PROJECT: PEDESTRIAN PLAZA
BID # CB-2543
Abilene, Texas

FROM: *la terra studio, LLC*
Michael Black, RLA
214.749.0333
12001 North Central Expressway, Suite 1170
Dallas, Texas 75243

This Addendum **No.3** forms a part of the Contract Documents and modifies the original Bidding Documents dated **May 30th, 2025** as noted below. Acknowledge receipt of this Addendum must be included with a bid submission. Failure to do so may subject the Bidder to disqualification.

1 TYPICAL PEDESTRIAN CONCRETE PAVING AND EXP. JOINT - SECTIONS

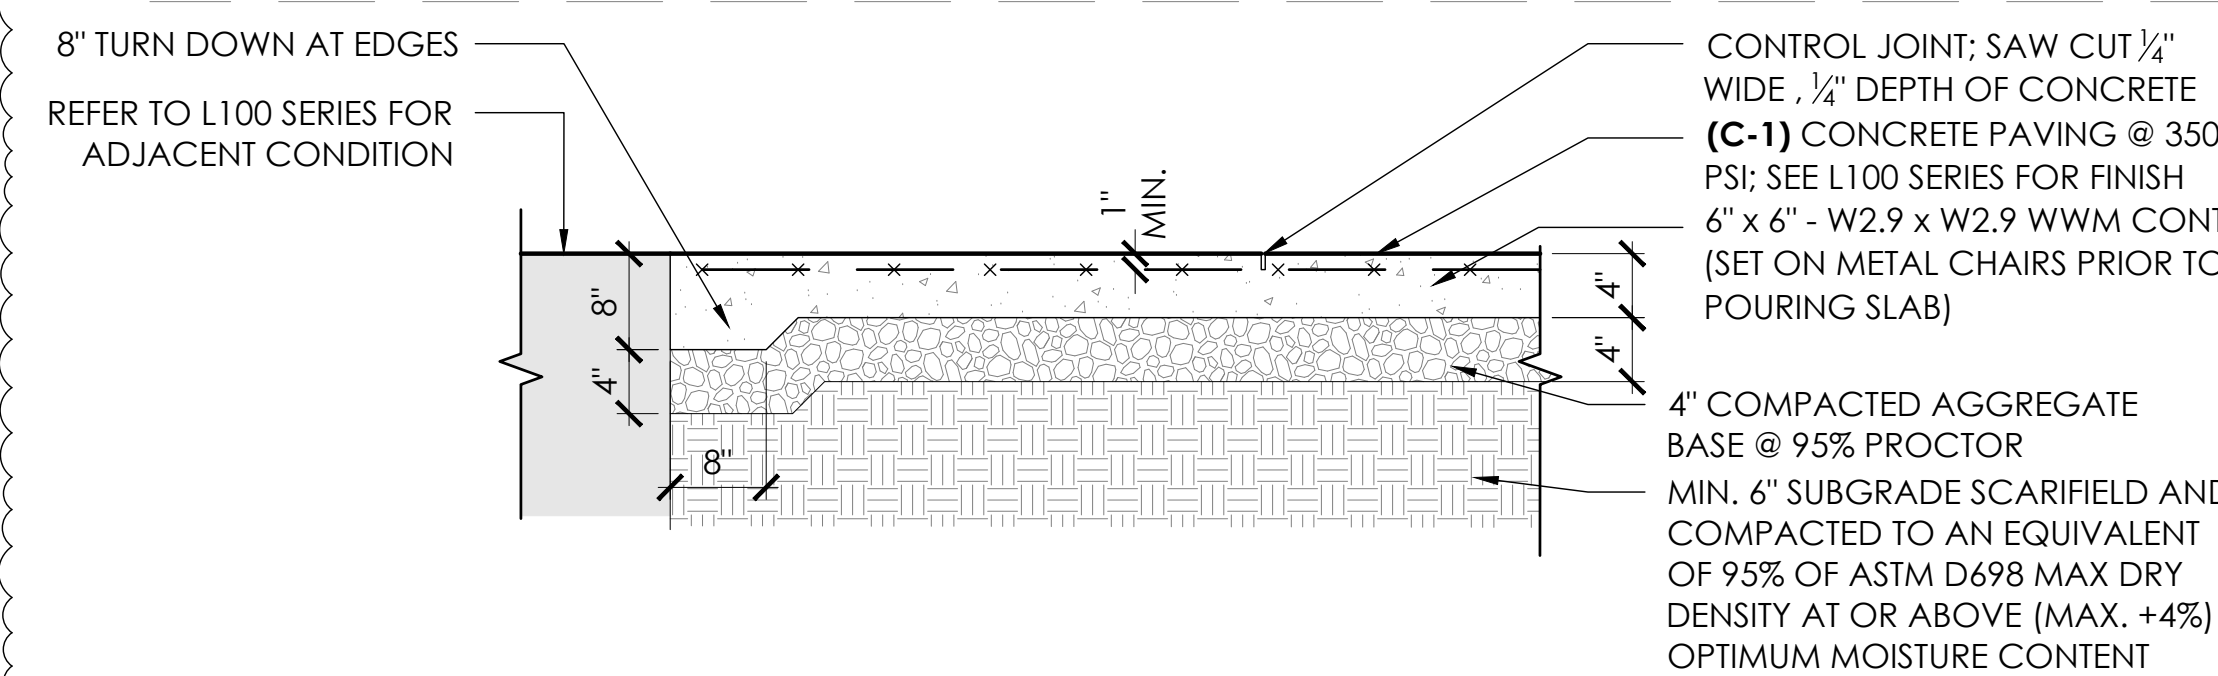
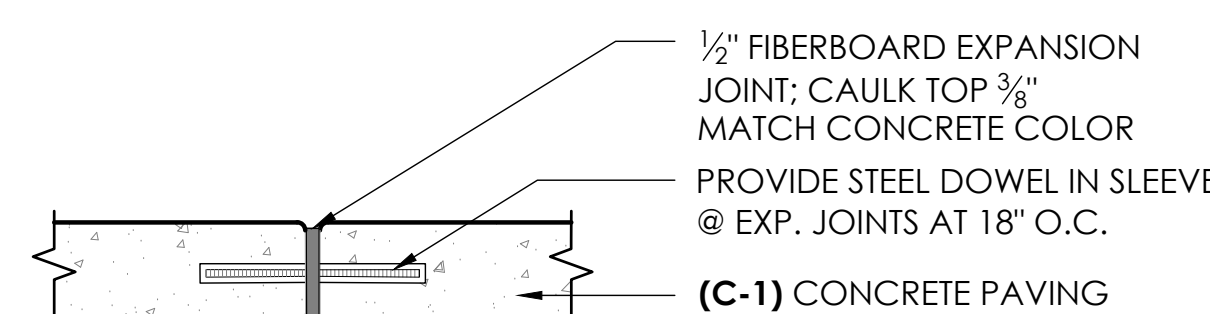
1. Revised Irrigation Drawing (L6.00), provides irrigation to solid sod grass area.
2. Revised Irrigation Drawing (L6.10), provides rotary head detail and removes drip indicator head detail.
3. Revised Detail 1 on Sheet L4.00.
4. The rebar pin was removed from the Quarry Limestone Block Fence section. Detail 6, Sheet L4.10 and Detail 7, Sheet L4.10.
5. The tongue and groove wood type is now SPF (Spruce, Pine, Fir) on Sheet L4.30
6. Reference to Security Cameras removed from Sheet L0.01.
7. Revised Sheet: Structural Steel Information for water feature
8. Revised Sheet: Concrete Pedestal civil details for water feature
9. The roof slopes for the pavilion are:
